# 1956 AMC-Hudson

Groups 1.000 thru 13.000

# AMERICAN MOTORS CORPORATION

## AUTOMOTIVE TECHNICAL SERVICE

FIGURE 1  
Approximate Location of  $11/64$ " Diameter Holes  
Drilled in Timing Chain Cover

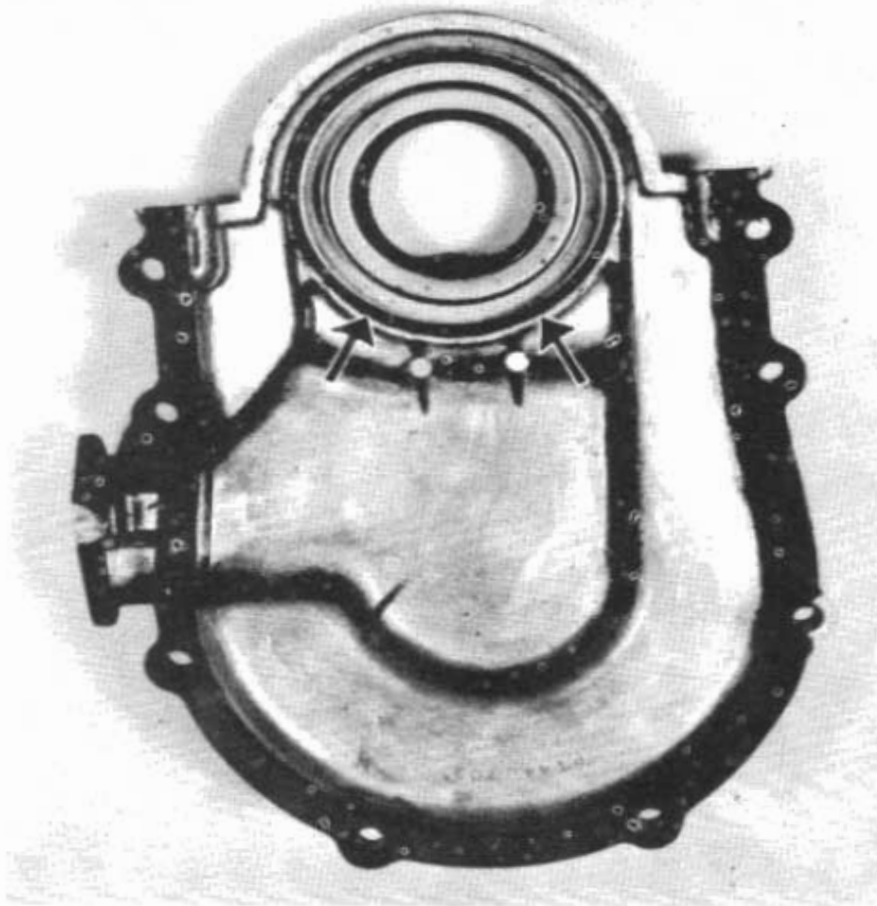
An oil leak at the front timing chain cover oil seal may result from a lack of an interference fit of the seal in the cover. This would permit the seal to turn with the crankshaft,

Remove timing chain from engine. Pry out old seal assembly from engine side of cover. Drill two 11/64" holes at location illustrated in Figure 1, American Motors Technical Service Att. #56-2.

FIGURE 2  
"Upset" Seal Material  
Into Drilled Holes in Cover

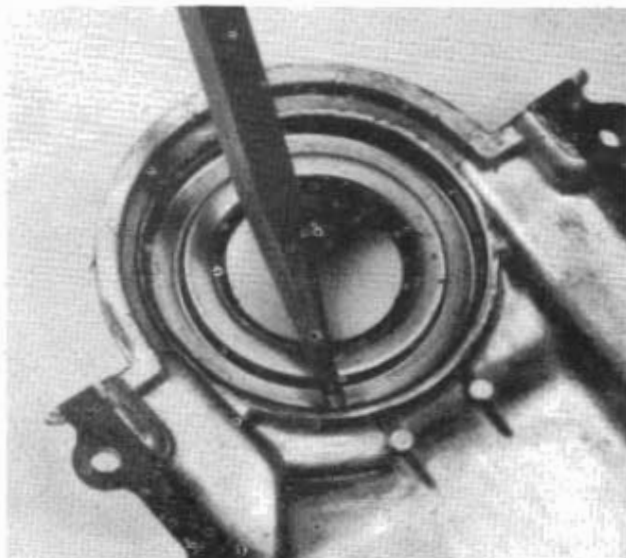
Install new oil seal with Tool J-5983. Upset the seal material into holes with a blunt pointed punch as shown in Figure 2.

FIGURE 1

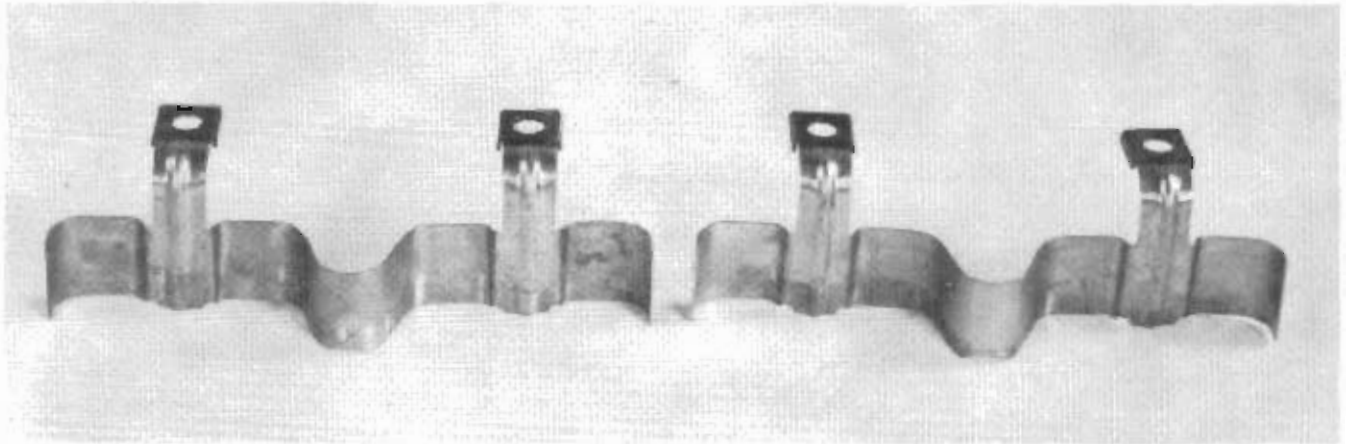
For service installation, WHERE VALVE GRINDING IS NOT REQUIRED, a special baffle kit, Part Number 6484396, consisting of 4 pieces valve spring baffle, Part Number 6489127, and 8 lockwashers, Part Number 6489048, may be installed without necessity of valve spring removal.

American Motors Technical Service Att. #56-8 illustrates the installation of the baffle contained in Part Number 6484396, Service Kit.

FIGURE 2

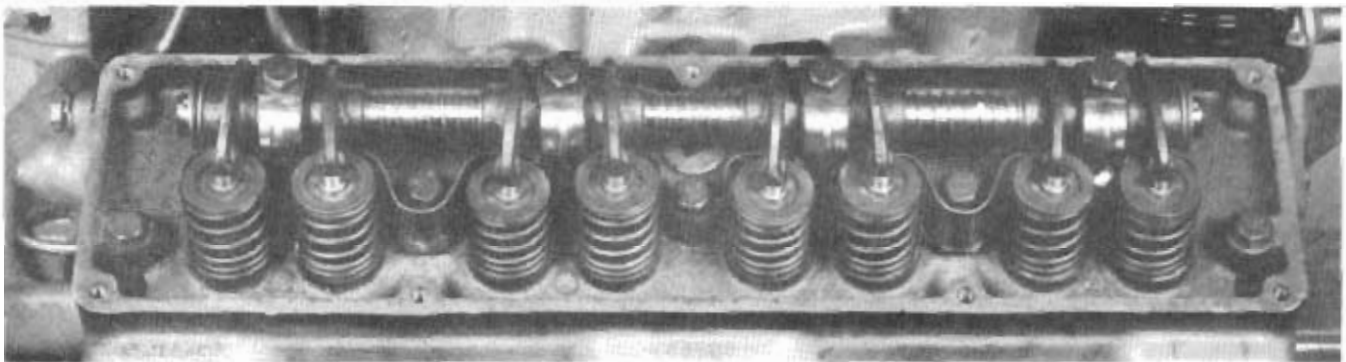
Place the baffles in position on the rocker arm assembly as shown in Figure 2. Install the assembly on the cylinder head. Replace the original rocker arm shaft bolt lockwashers with the square type lockwashers.

FIGURE 1

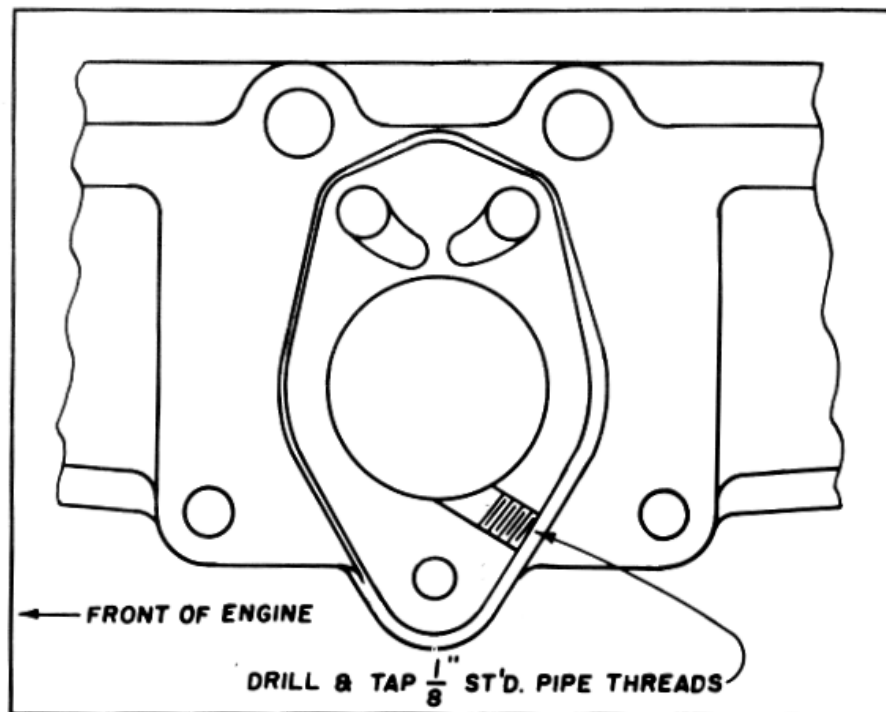
Mark and drill a  $21/64$ " hole in the left rear side of the carburetor mounting pad as shown in the illustration.

Tap the hole with a  $1/8$ " standard tapered pipe thread.

FIGURE 1  
CARBURETOR THROTTLE ROD AND  
ADJUSTER ROD MEASUREMENT

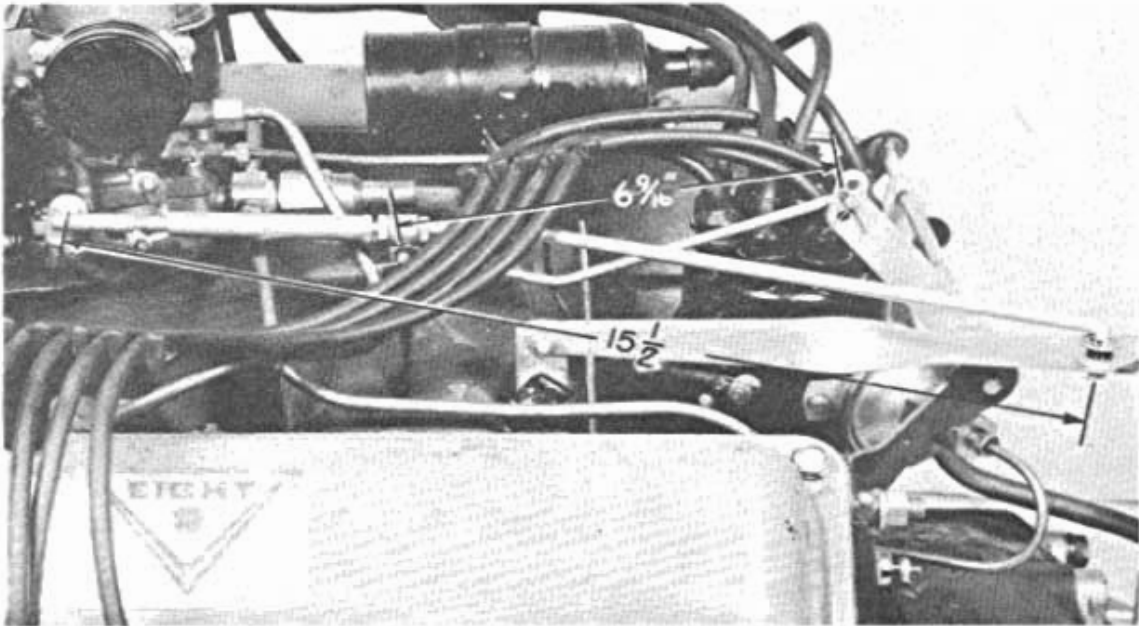
The adjuster rod that is connected to the carburetor throttle rod and to the lever of the cross shaft must be 6-9/16" from center to center of ends of rod. If the rod is either too long or too short, bend rod at present bend to obtain the correct length of 6-9/16".

FIGURE 2  
T.V. ROD MEASUREMENT

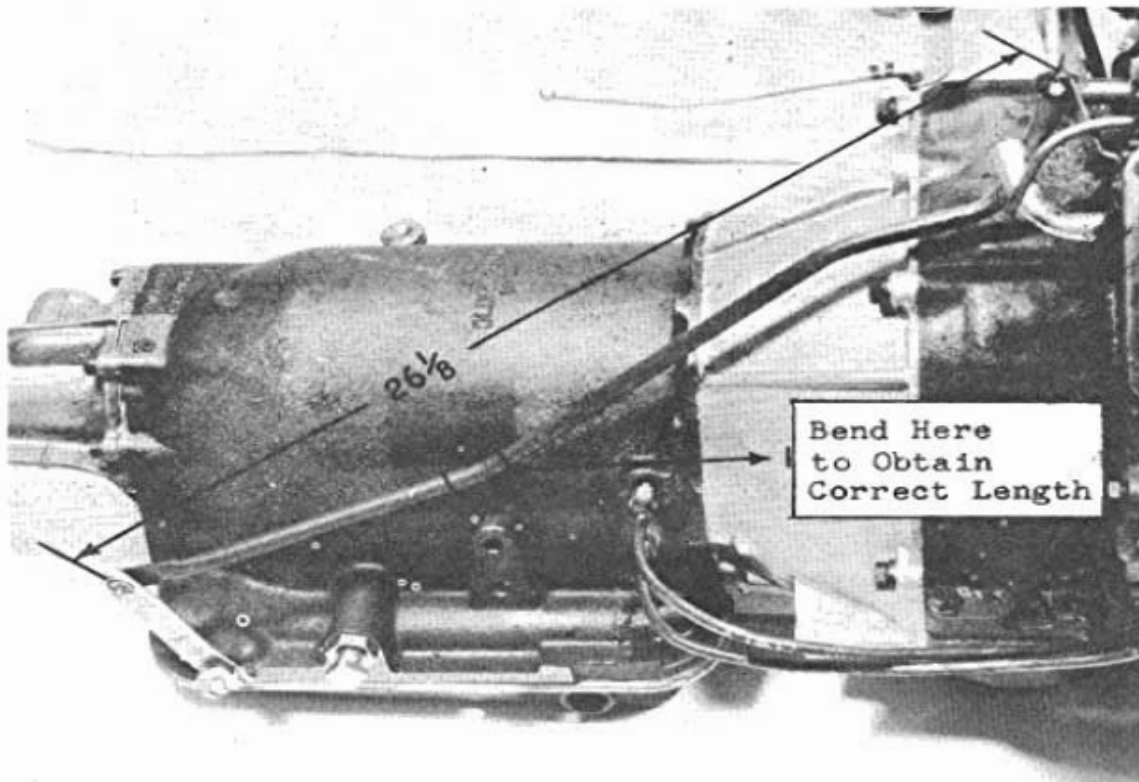
The T.V. rod from the cross shaft lever to the T.V. lever at the transmission must be 26-1/8" from center of pins, This rod must also be bent to obtain the correct measurement (Fig. 2).

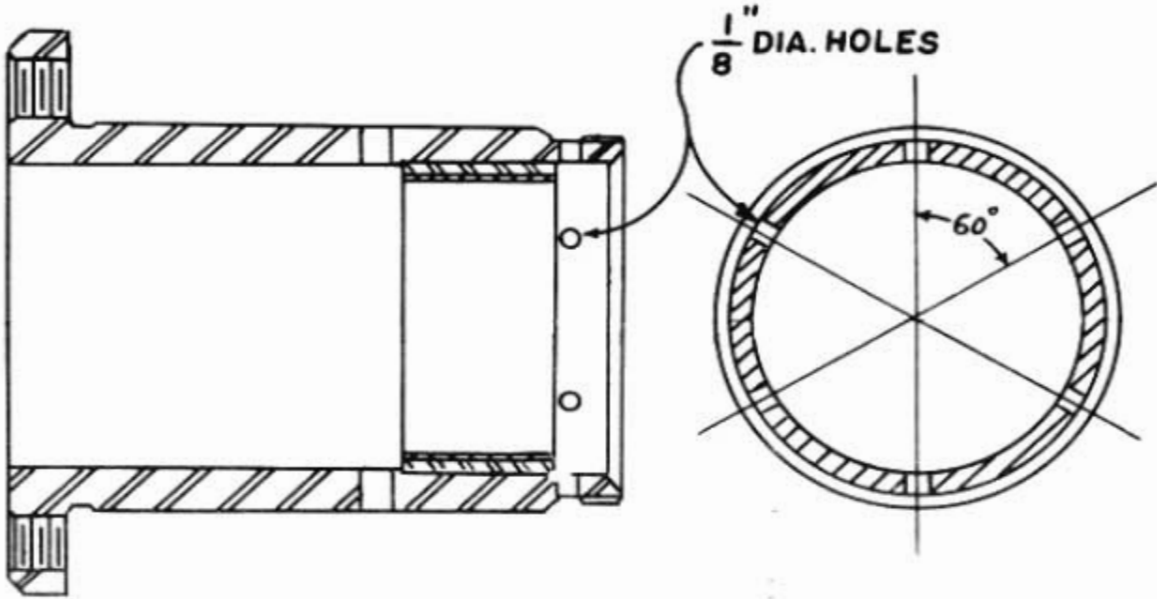
Where it is found necessary to replace a new pump assembly, Part Number 6484527, or a new rotor assembly, Part Number 6469367, in the 1955 Series, the original converter pump shaft **MUST** be drilled with six 1/8" holes properly indexed in six places in the groove behind the splines as illustrated in American Motors Technical Service Att. #56-7. After drilling, all burrs and sharp edges must be removed.

FIGURE 1  
Shock Absorber Lower Mounting  
Bracket Brace

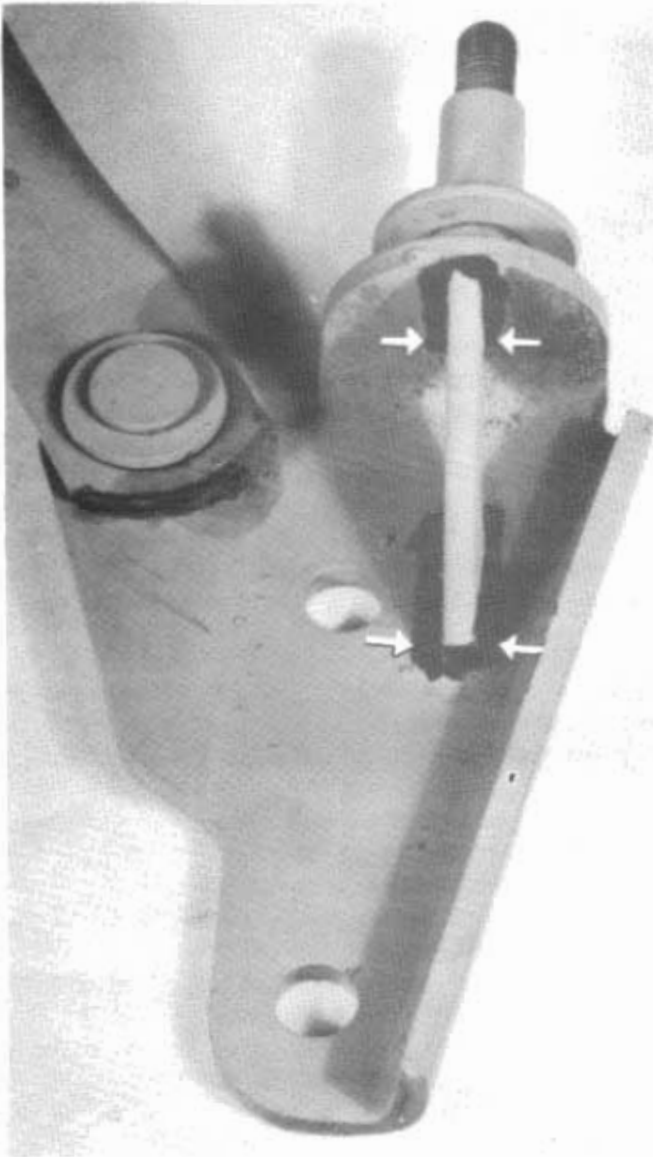
Effective at car serial number D-277527, a brace, Part Number 3148777, was added to the rear axle truss rod and shock absorber bracket to prevent bending of the bracket and resultant shock absorber damage.

Figure 1, American Motors Technical Service Att. #56-3 outlines the welding location of the brace.

FIGURE 2  
Shock Absorber  
Upper Mounting Reinforcement

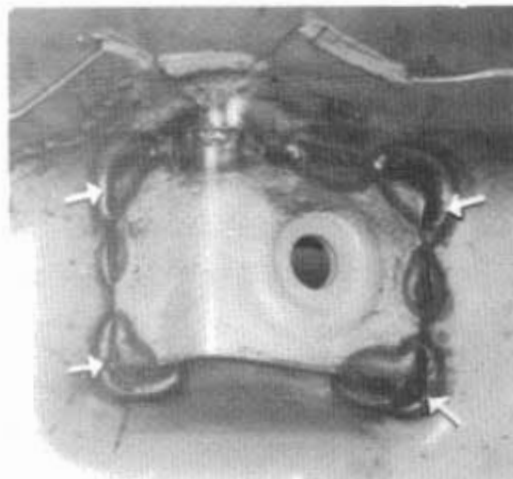
A reinforcement, Part Number 3415299, has also been added to the body crossmember at the point where the upper end of the rear shock absorber is attached. This reinforcement was added in production at car serial number D-279100.

Use a bolt and nut through the shock absorber bayonet hole to hold the reinforcement in place while arc welding. Figure 2 outlines the location and welding of the reinforcement.
